SIMON NO. 1 DAM (AKA CROSHO)
Outlet Replacement Project
Construction Completion Report
August 27, 2019

Date: 9/5/2017 AG Job No.: 16-103
To: Dana Miller, P.E.
From: Craig Ullmann, P.E.
Subject: **Simon No. 1 Dam – Change Order No. 1 - Dam ID 580133, Construction File No. C-0133A**

Date: 11/2/2017 AG Job No.: 16-103
To: Dana Miller, P.E.
From: Craig Ullmann, P.E.
Subject: **Simon No. 1 Dam – Change Order No. 2 - Dam ID 580133, Construction File No. C-0133A**

Client: Crosby Lake Corp Job No: 16-103
Project: Outlet Replacement By: CMU Date: 9-4-17
Description: Backfill Modifications Chk: _____ Date: _____
Page: 1 of: 1

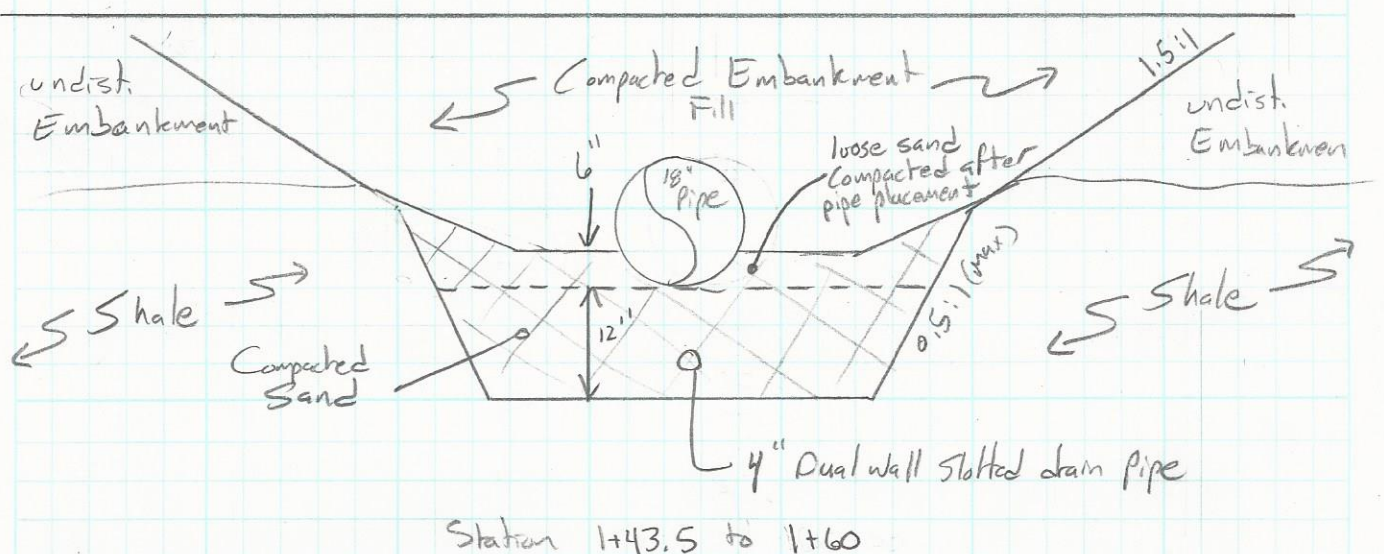
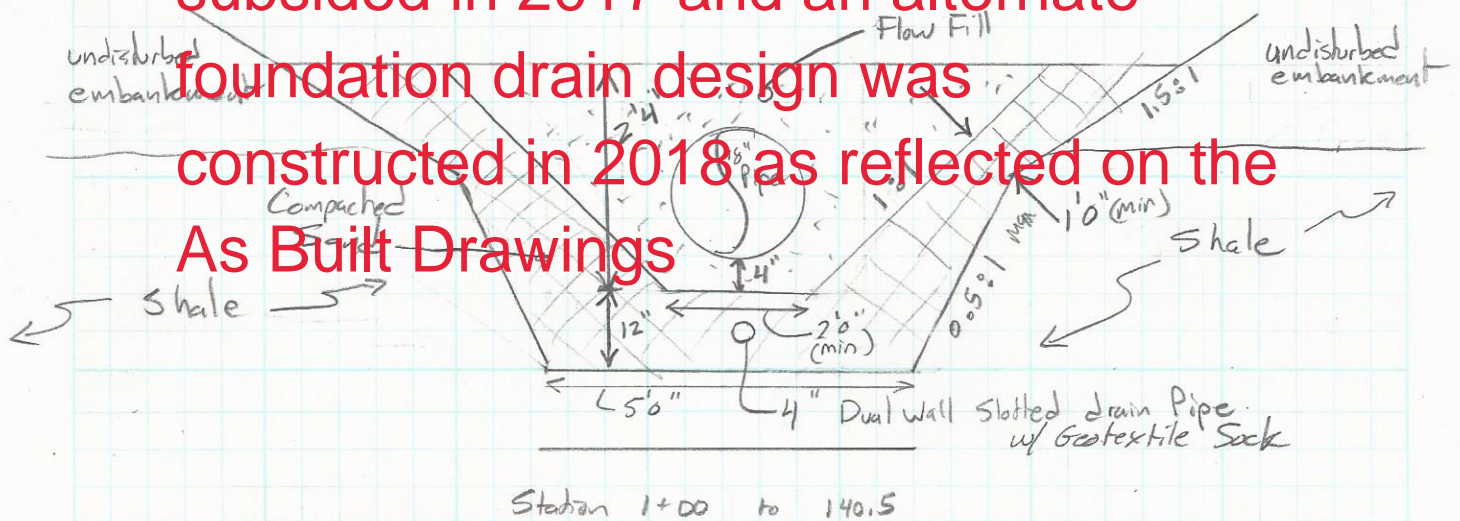
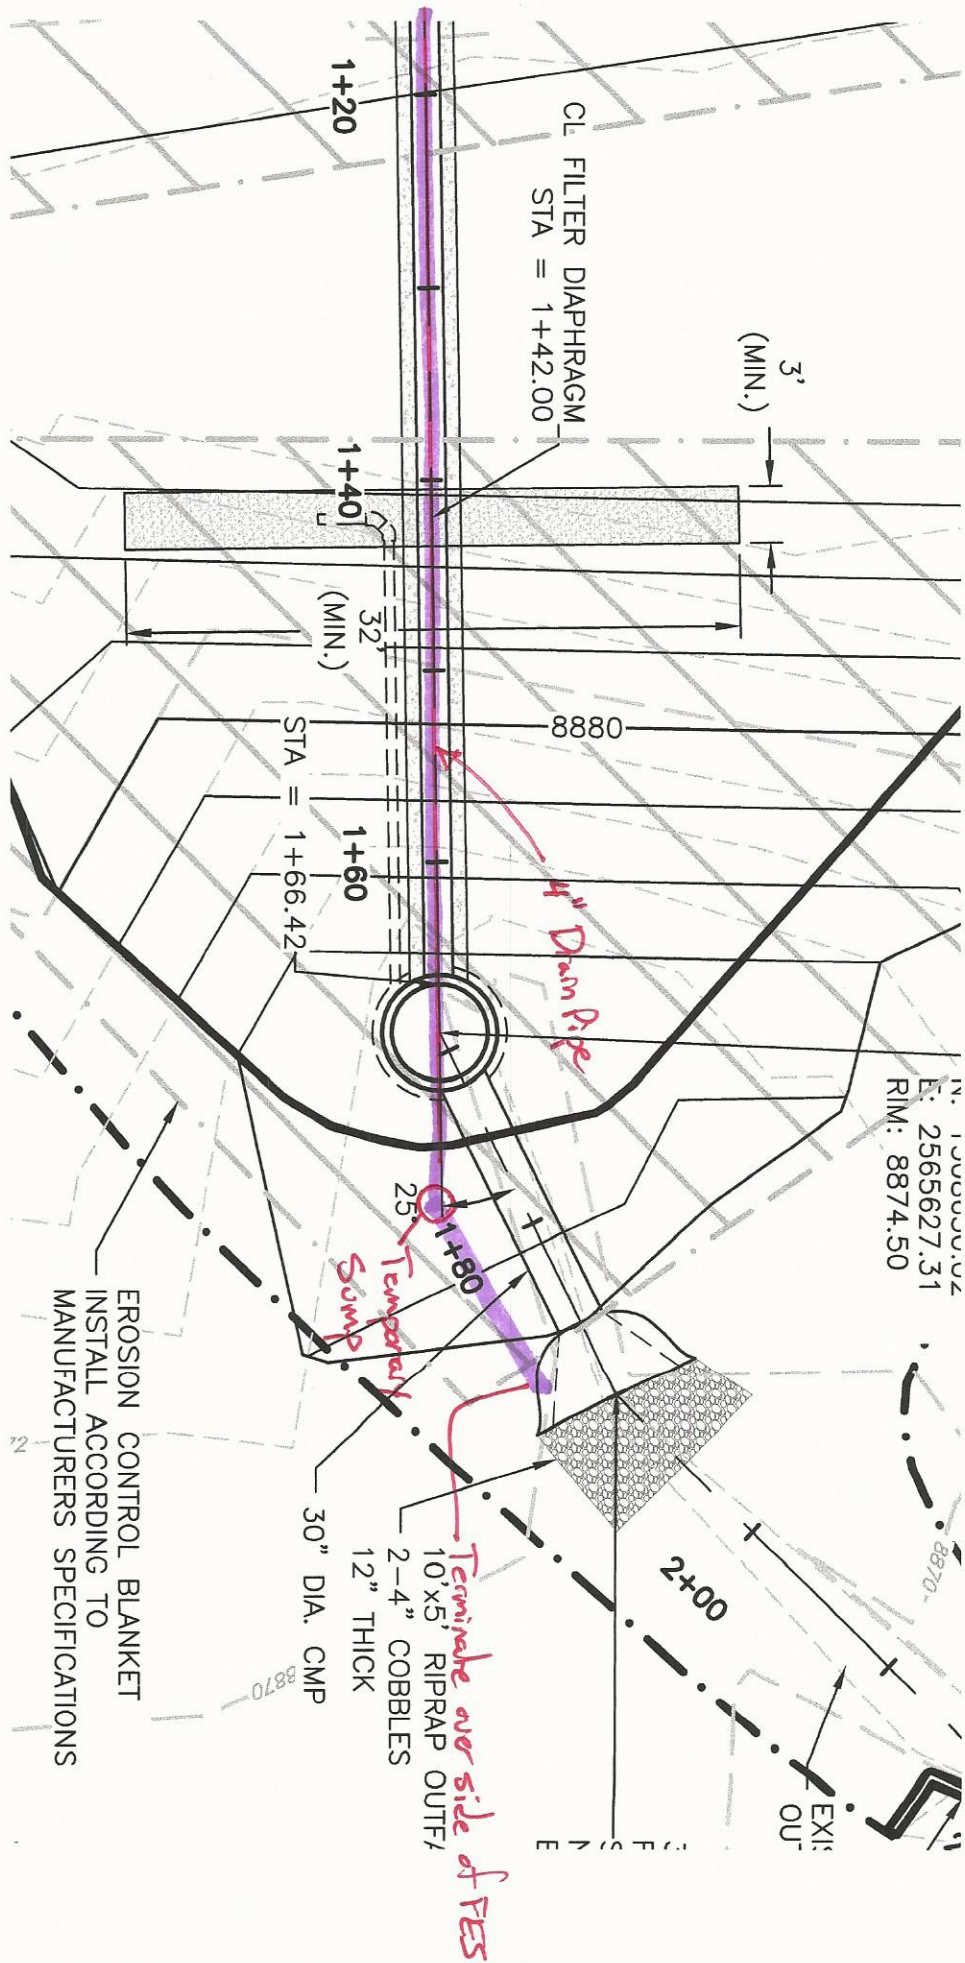
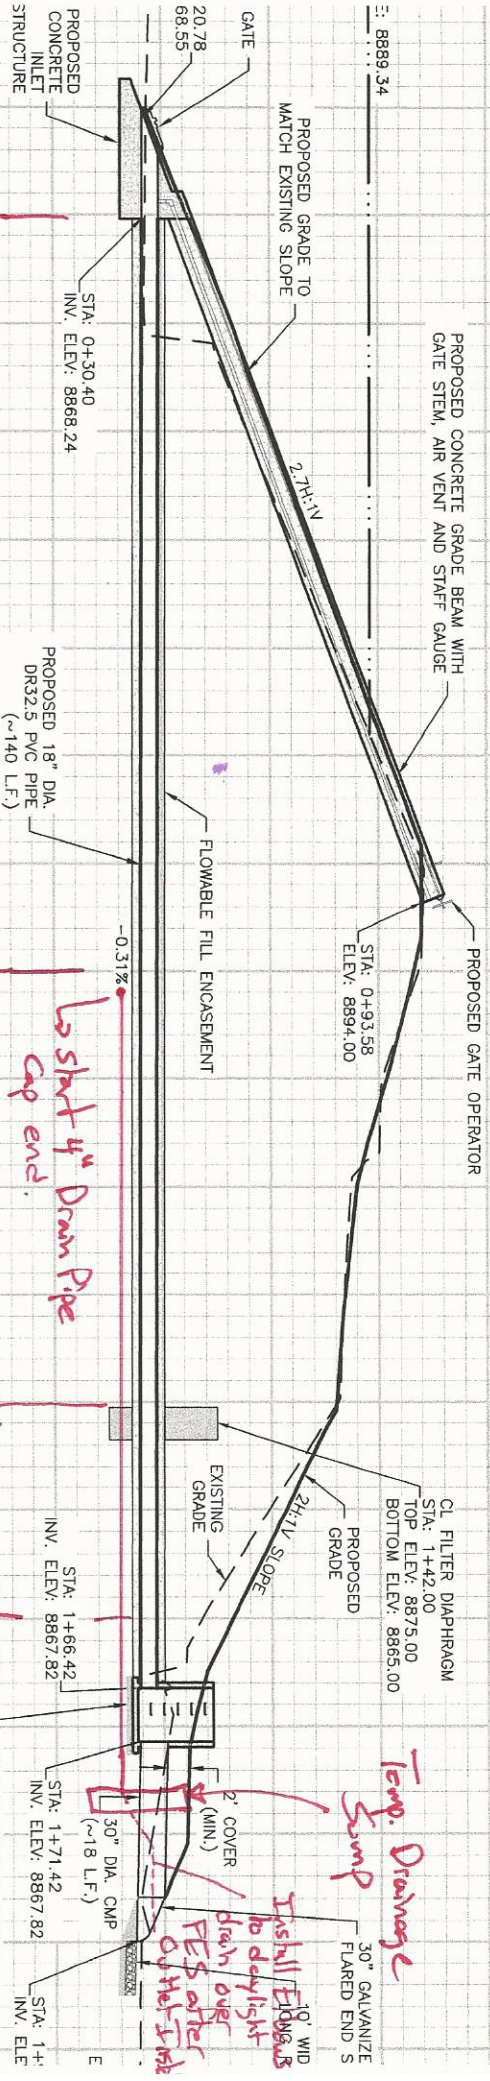
- Station 0+30 to 1+00 – The pipeline in this reach will be constructed per the approved design Embankment material will be placed in compacted lifts up to the top of the proposed flow fill. A trench will then be excavated to the dimensions shown on the plans.

- Station 1+00 to 1+40.5 – The trench in this reach will be excavated 12 inches deeper than anticipated, however, the first 12 inches of backfill will be sand meeting the same specifications as the sand collar. A 4 inch dual wall slotted HDPE pipe will be placed at the same grade as the pipeline in the center of the sand zone. This pipe will begin at station 1+02 and will have a cap on the end. A geotextile drain sock will be used around the drain pipe to prevent sand from entering the slots. Due to the temporary nature of this drain and the physical constraints of the site we feel that a geotextile is appropriate. Sand will also be placed up the sides of the shale layer as shown on the attached sketches in order to intercept water exiting the fractures in the shale. The sand will be compacted as dictated in the specifications, using 3 passes of a vibratory plate compactor. The sand on the sides will be overbuilt to allow compaction and the re-excavated as required to shape the excavation for the flow fill. The pipe will be placed in this trapezoidal trench and anchored/weighted in preparation for flow fill placement.

- Station 1+40.5 to 1+43.5 – This section is where the pipe passes through the sand diaphragm. The flow fill that was originally shown to extend to station 1+66 will now terminate at station 1+40.5. The sand collar will be placed directly against the pipe. The new 4 inch drainline will continue through this section.

- Station 1+43.5 to 1+66 – The bottom of the trench will be construction similar to station 1+00 to 1+40.5 with sand and a drain pipe. The difference will be that the 18 inch outlet pipe will be backfilled with compacted embankment material rather than flow fill. The pipeline will be bedded in 6 inches of loose sand. After placing the pipe the sand will be compacted with hand tools. Then 9 inches of loose embankment material will be

- Sta 1+60 to 1+66 – Backfill in this section will transition to all embankment fill. Sand will terminate by at least station 1+60 and earlier if seepage is less than expected. The 4 inch drain pipe will transition to solid wall pipe backfilled with embankment material. This solid wall pipe will continue straight under the manhole as shown in the attached drawing where it will terminate in a section of culvert pipe that will be used as a sump.

Not Constructed, groundwater subsided in 2017 and an alternate foundation drain design was constructed in 2018 as reflected on the As Built Drawings

Description: Slide gate angle adjustment

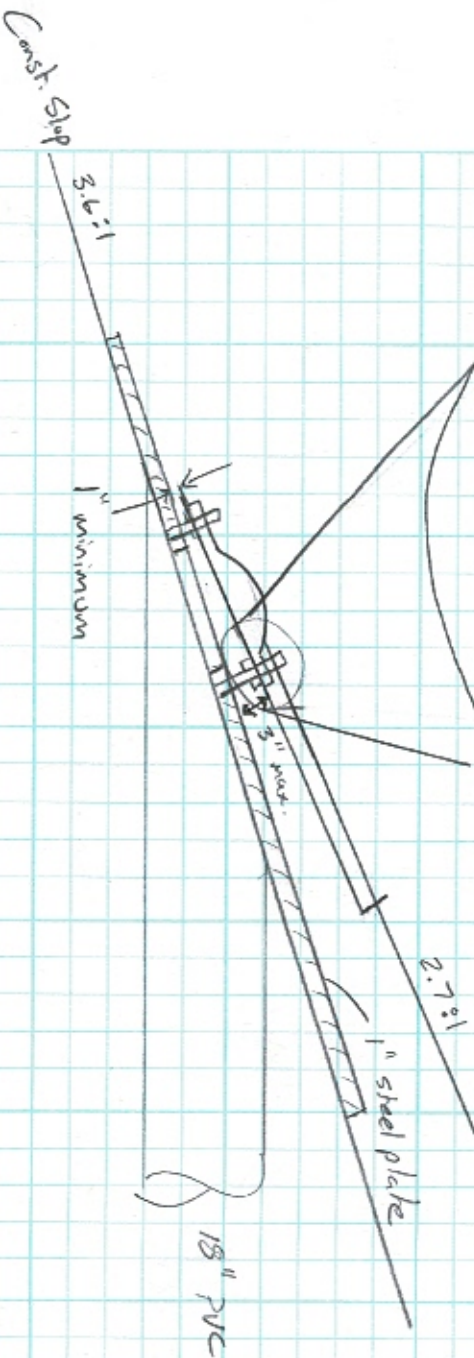
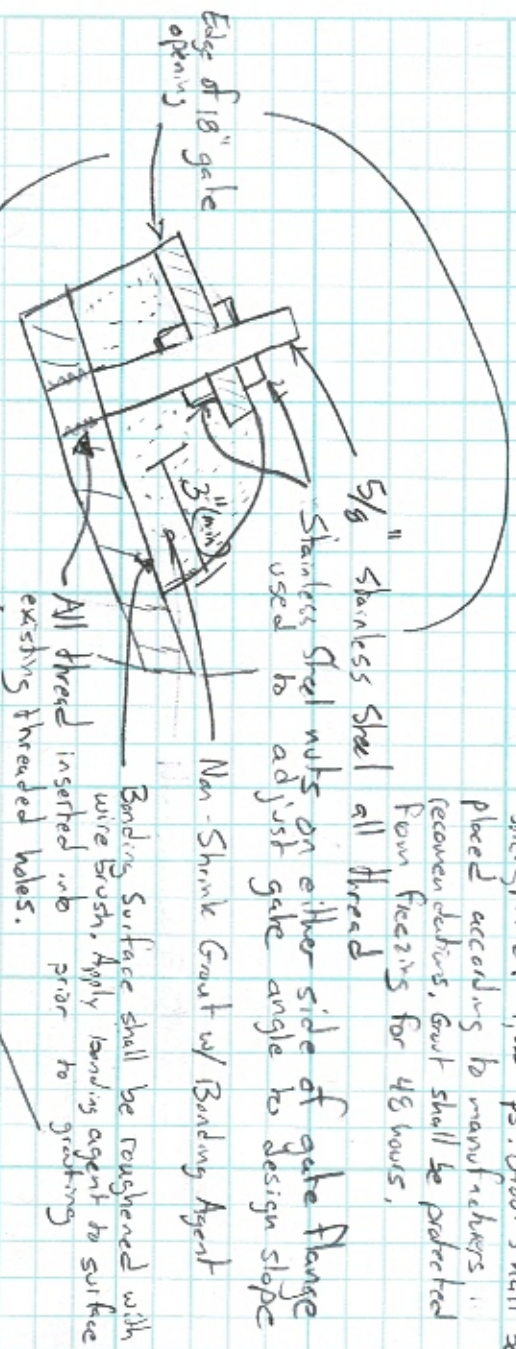
As previously discussed the outlet pipe and intake structure were placed over 3 feet higher than the design plans indicated. The contractor has corrected the elevation of the pipe by excavating the pipe and sliding the constructed inlet structure aside. The grade under the structure was corrected and the inlet structure was slide back into position. While the elevation of the pipe inlet was corrected the inlet structure was not placed at the correct angle. The design slope was to match the upstream dam slope of 2.7H:1V whereas the constructed slope of the gate has been measured at 3.6H:1V. This would result in the stem of the slide gate projecting through the dam and out the downstream slope. In order to correct this deficiency we discussed the issue with the gate supplier, Municipal Treatment Equipment of Golden, Colorado and recommend the following repair procedure, also see the attached sketch.

- The resulting space between the slide gate and steel plate should then be grouted with a non-shrink grout with a bonding agent added to improved adhesion between the grout and adjacent surfaces. A minimum gap of 1" and a maximum of 3" is specified to allow proper grouting between the slide gate flange and the steel plate. Grout will be mixed by hand or with a mixer blade attached to a drill. Water used for mixing will be brought from off site. Grout should completely fill the gap between the steel plate and gate flange and be placed to the extents shown on the attached sketch. The grout submitted by the contractor meets our requirements and is attached for reference along with the bonding agent. This grout will be mixed in a plastic state in order to allow placement by hand.

Thank you for submitting the Change Order request for modification to the intake gate in order to adjust the angle of the gate and stem. This adjustment is necessary to correct the angle at which the intake structure was reset. Based on our review of the Change Order request we find this change in the approved plans and specifications to be acceptable and approved as of the date of this letter.
